Technical Memorandum

Title Flinders Neighbourhood 3a & 3b

Review of Road Hierarchy Compliance with Infrastructure Master Plan (IMP)

Client Morton's Urban Solutions

Figure 2-1 Locations of footpath design inconsistencies

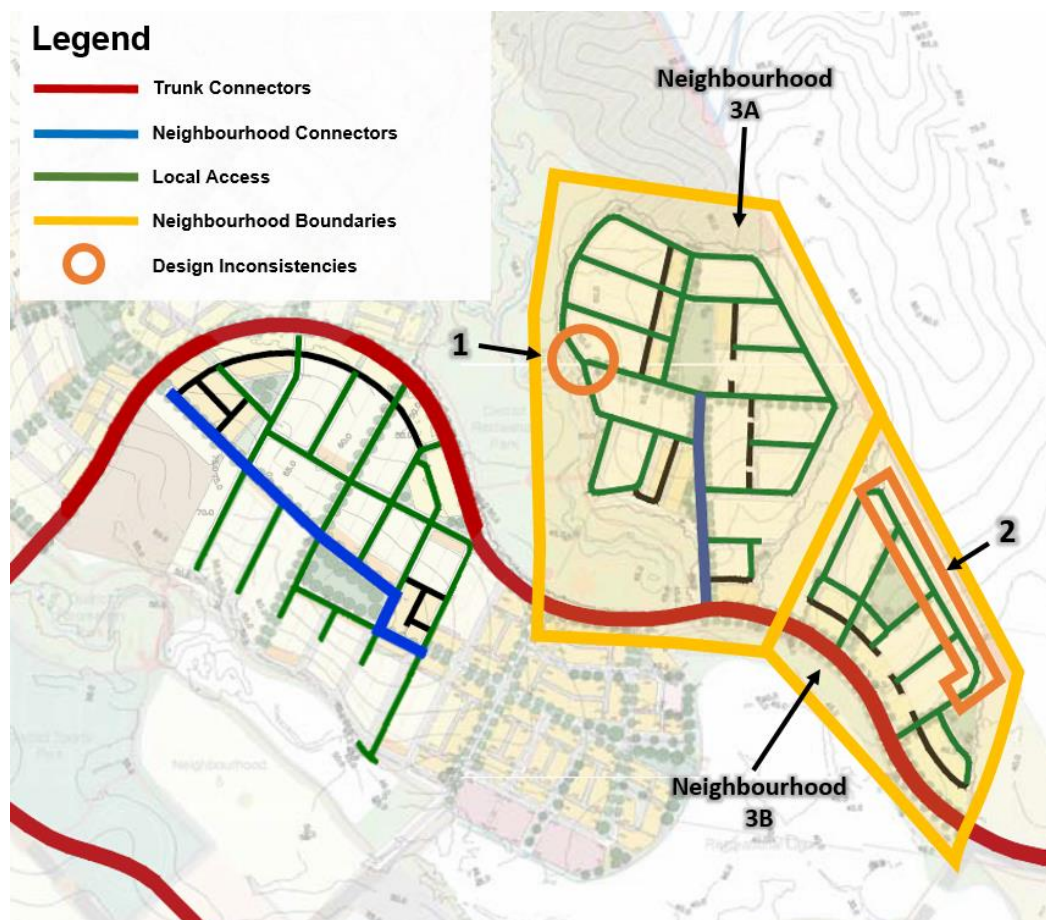
Issue 1 – Footpath adjacent to Parkland

The road section highlighted in Figure 2-1 has a footpath on one side of the road only.

This road is considered a “Local Access Type 3B” connector as described in 4.5.3 of the IMP with locations and design criteria in 5.2 of the Bicycle Strategy. “Flinders Proposed” as described in Table 5.2 of the Bicycle Strategy states 2 x 1.5m pedestrian paths (both sides) are required.

The road connector does not have a path on the south side at the western end of the segment. Figure 2-2 shows the road connector spanning all the way to the western end of the park and thus possessing the same characteristics.

However, links classified as “Local Access Type 3C” connector as described in 4.5.3 of the IMP with locations and design criteria in 5.3 of the Bicycle Strategy are only required to have a footpath on one side, as park lands exist on one side. This connector is labelled as “Local Access Type 3B” but the design and location is consistent with “Local Access Type 3C” connectors. “Local Access Type 3C” roads only require 1 x 1.5m footpath (one side) when adjacent to parkland, as shown in Figure 2-4, therefore the provision of a footpath on the south-western side only at this location is considered to be conforming.

Figure 2-3 Locations of Local Access Type 3B footpaths

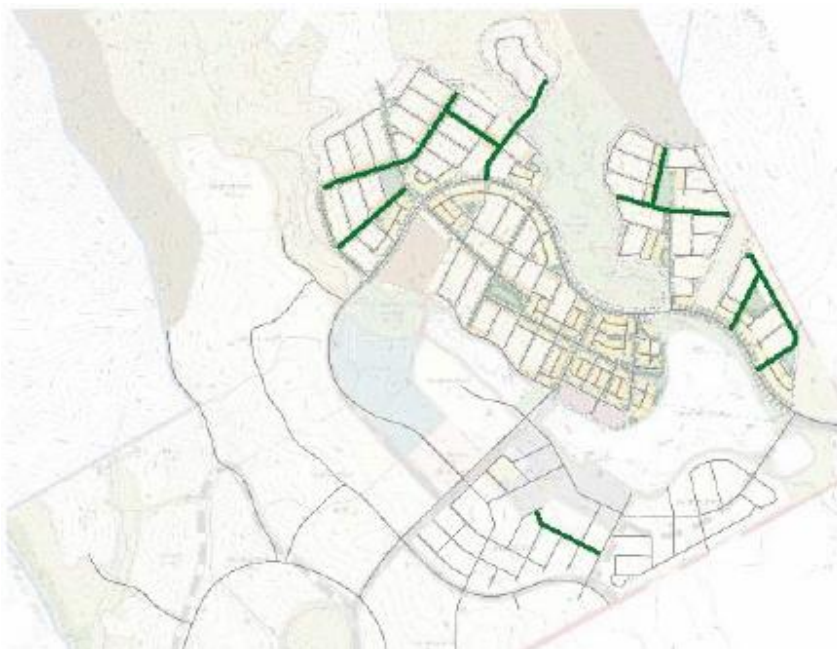
The locations of “Local Access Type 3B” connectors and the design criteria proposed by Flinders is shown in Figure 2-3 and Figure 2-4.
